LARAMIE COUNTY PLANNING & DEVELOPMENT DEPARTMENT

MEMORANDUM

TITLE: Review and action of a Subdivision Permit and Plat for North Range

Business Park, 10th Filing, a replat of a portion of Lot 1, Block 15, North

Attachment 5: Plat Map Revised 02.21.18

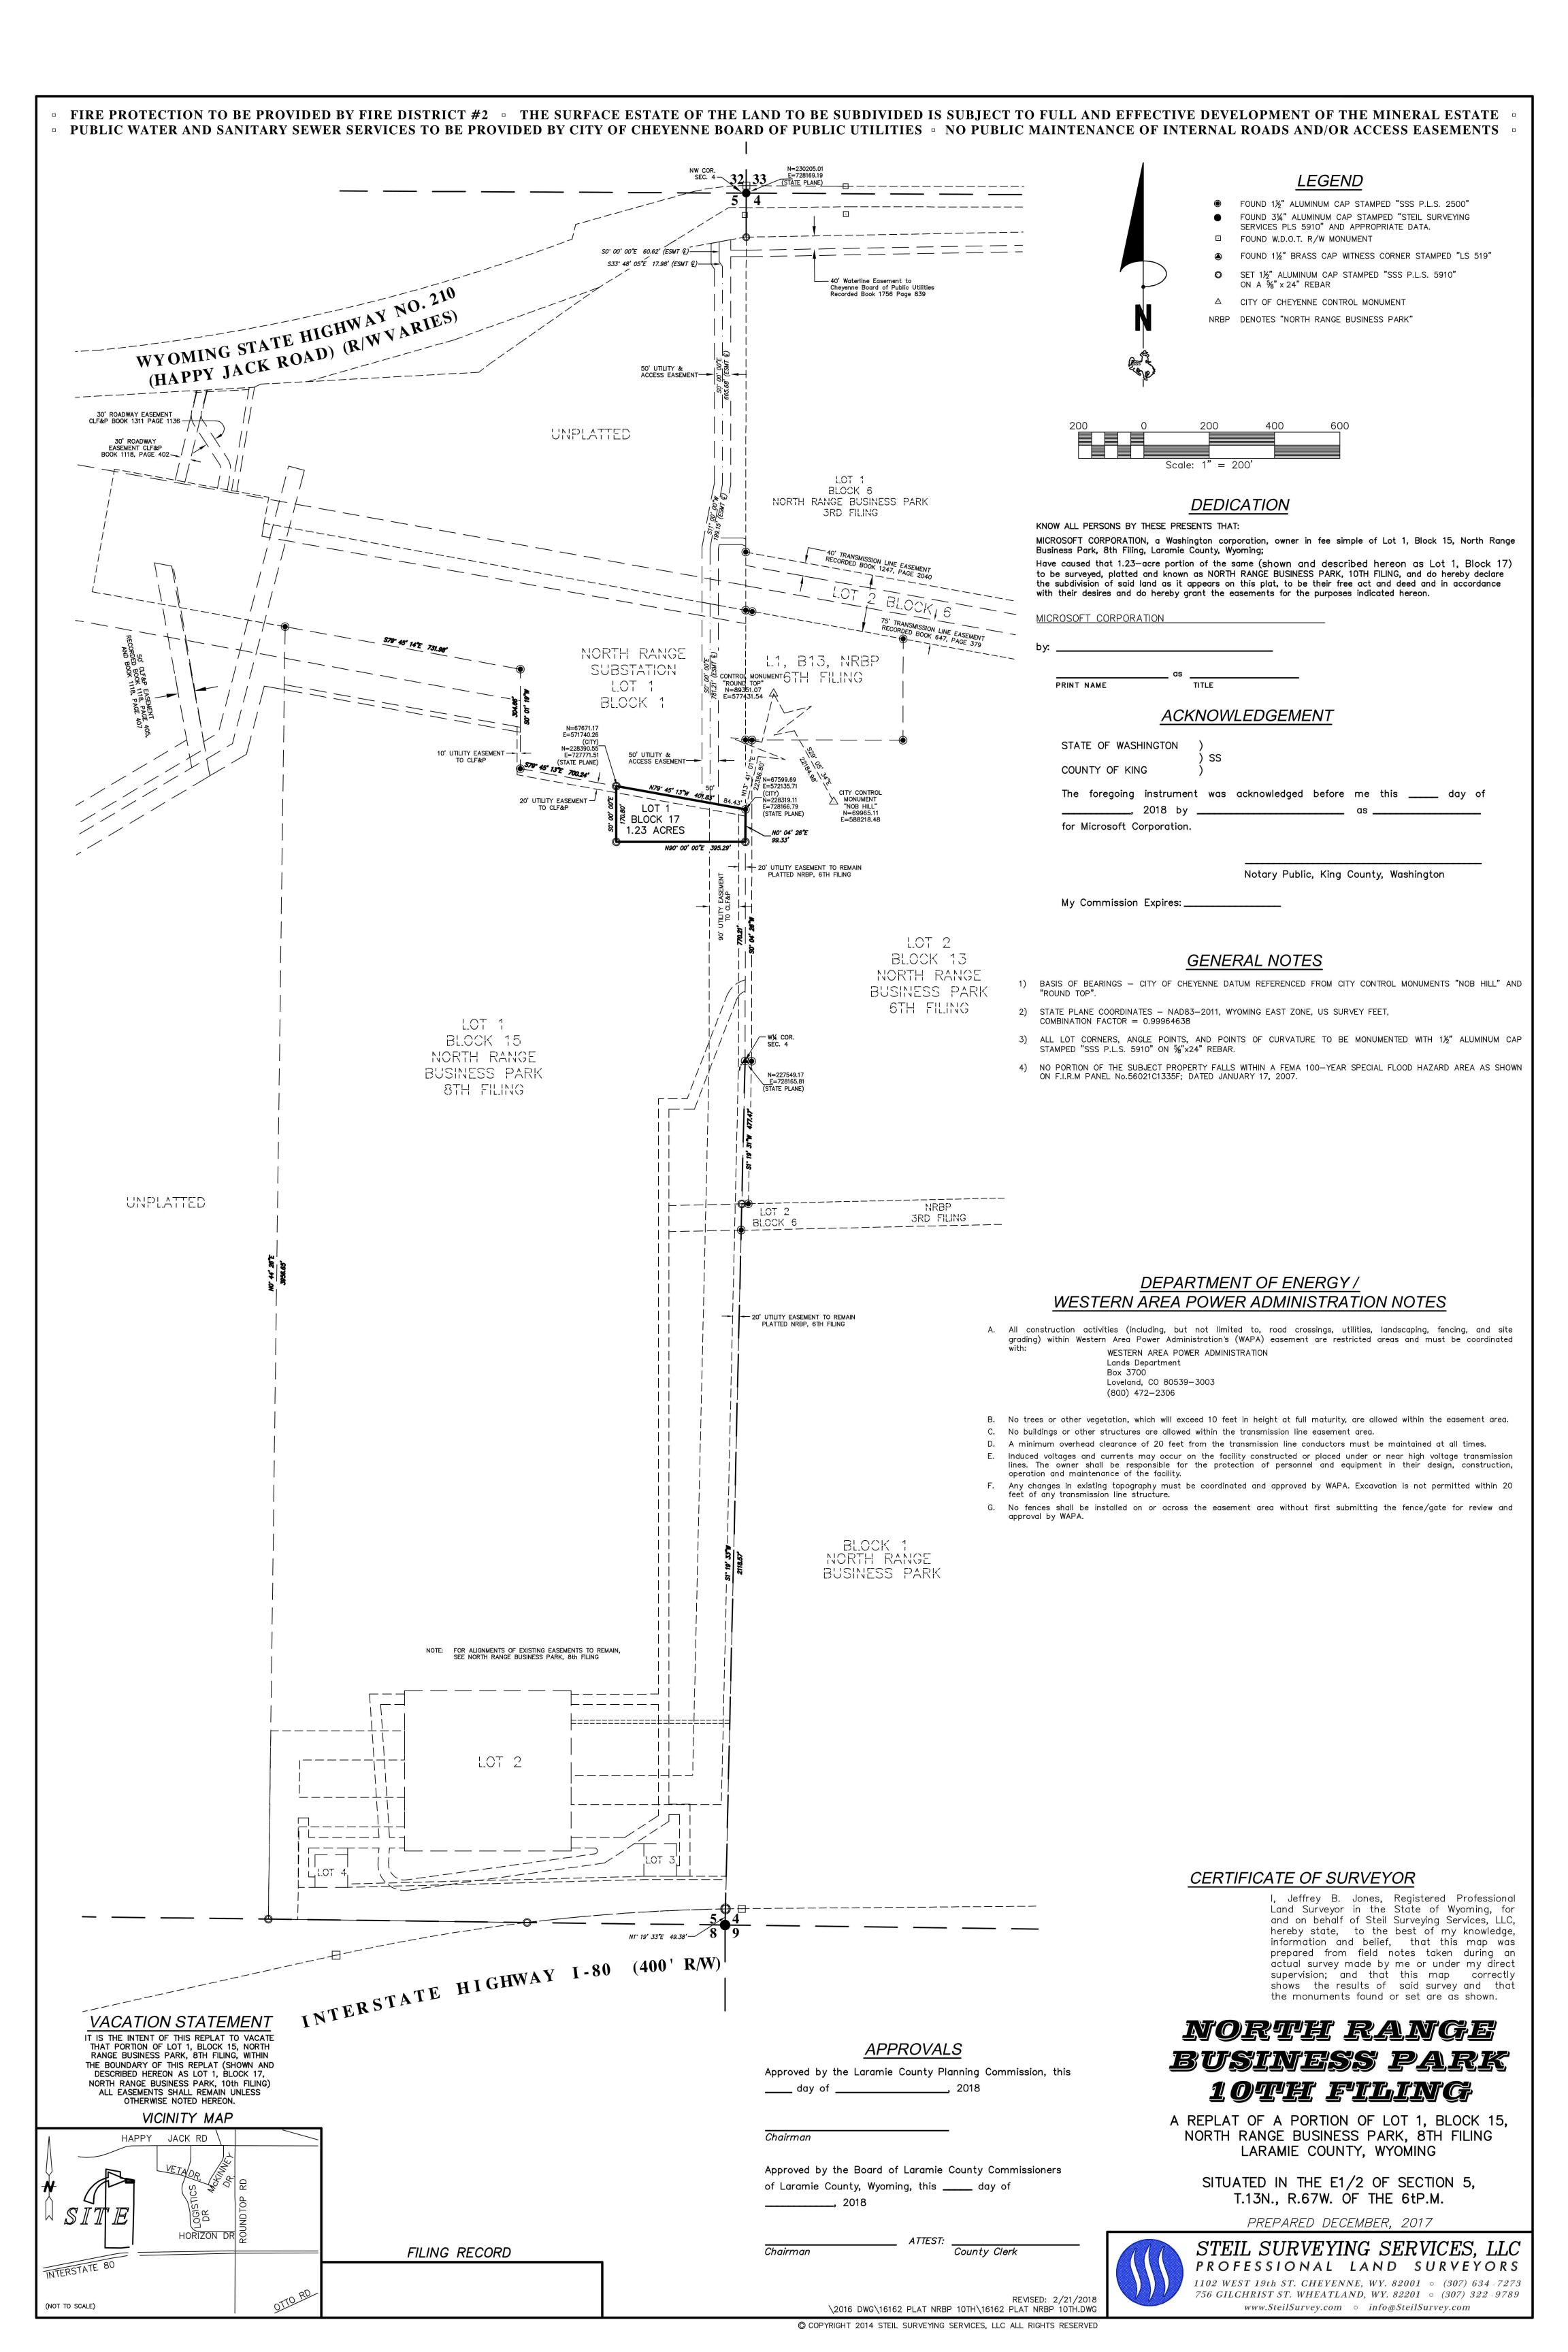
- 1. Plats are required to include the Section, Township and Range within the title.
- 2. Plats require that dedication and acknowledgment statements must be executed by all owners of legal and equitable interests in the property being subdivided/developed. From the description in the Title Block and after reviewing the plat, it appears that the purpose of this plat is to re-plat a portion of Lot 1, Block 15 of North Range Business Park 8th Filing. The Dedication states: "MICROSOFT CORPORATION, A Washington corporation, owner in fee simple of Lot 1, Block 15, North Range Business Park 8th Filing, Laramie County, Wyoming:" The next paragraph states: "Have caused the same to be surveyed platted and known as NORTH RANGE BUSINESS PARK 10TH FILING......." The dedication seems a little confusing, it seems to state that all of Lot 1, Block 15, North Range Business Park 8th Filing, as re-platted heron, is now "known as NORTH RANGE BUSINESS PARK 10TH FILING". Should all of Lot 1, Block 15, North Range Business Park 8th Filing be included in this re-plat, renaming Lot 1, Block 15 of North Range Business Park 8th Filing to Lot 2, Block 17 of North Range Business Park 10th Filing? It would certainly clarify many of the questions that the future users of this plat may have.

- 3. Plats require that if any lot, block, boundary or right-of-way from a previously recorded plat is being vacated by this plat a notation shall be provided, describing the area or boundaries to be vacated under a section titled Statement to Vacate. An executed "Petition to Vacate" signed by all affected owners is required as part of the application packet. The Vacation Statement is a little unclear. It appears that the intent of this plat to vacate and re-plat Lot 1, Block 15 of North Range Business Park 8th Filing or does this re-plat just include the area shown as Lot 1, Block 17, North Range Business Park 10th Filing? It might help clarify the intent by adding a little to the VACATION STATEMENT such as: IT IS THE INTENT OF THIS RE-PLAT TO VACATE THAT PORTION OF LOT 1, BLOCK 15, NORTH RANGE BUSINESS PARK 8TH FILING, WITHIN THE BOUNDARY OF THIS REPLAT (SHOWN ON THIS PLAT AS LOT 1, BLOCK 17, NORTH RANGE BUSINESS PARK 10TH FILING)...... It appears that no easements are proposed to be vacated.

- 4. Plat layouts shall include boundary lines with bearings/azimuths and distances and the location of all recorded rights-of-way intersecting the boundary of the subdivision. The locations of all recorded rights-of-way intersecting the boundary of the subdivision are not shown.

- 5. Plat layouts shall include the location and dimensions, with boundary ties, for all existing and proposed utility, drainage, access, or other easements. The boundary ties for all existing and proposed utility, drainage, access or other easements are not all shown. For one example, the 50' UTILITY AND ACCESS EASEMENT intersecting the North boundary of Lot 1, Block 17 is not tied. Where does it intersect the boundary?

- 6. Plat layouts shall include the right-of-way lines, widths and names of all streets or roads within and adjacent to the proposed subdivision/development. The only access to Lot 1, Block 17 shown on the plat is the 50' UTILITY AND ACCESS EASEMENT intersecting the North boundary of Lot 1, Block 17. What is its source? The only street or road shown on the plat is Wyoming State Highway No. 210 and I-80.

- 7. Plat layouts shall include such additional information as may be required to adequately describe proposed utility systems, street improvements and easements or reservations contemplated within the area to be subdivided. After careful review of the plat, I have to assume that all easements shown on the plat in the immediate area of Lot 1, Block 17, continue or extend through Lot 1, Block 17 of North Range Business Park 10th Filing. The easement contiguous to the East boundary of Lot 1, Block 17 of North Range Business Park 10th Filing is not identified, width, purpose or source.

- 8. Any recorded easements or restrictions applicable to the subdivision shall be noted by reference to Register's book and page number. The County will not be involved in the enforcement of deed restriction or covenant instruments. There are several easements shown on the plat. One of the easements shown refers to a previous filing of North Range Business Park. A number of them do not reference any source (maybe a previous filing) nor do they reference the Register's book and page number.
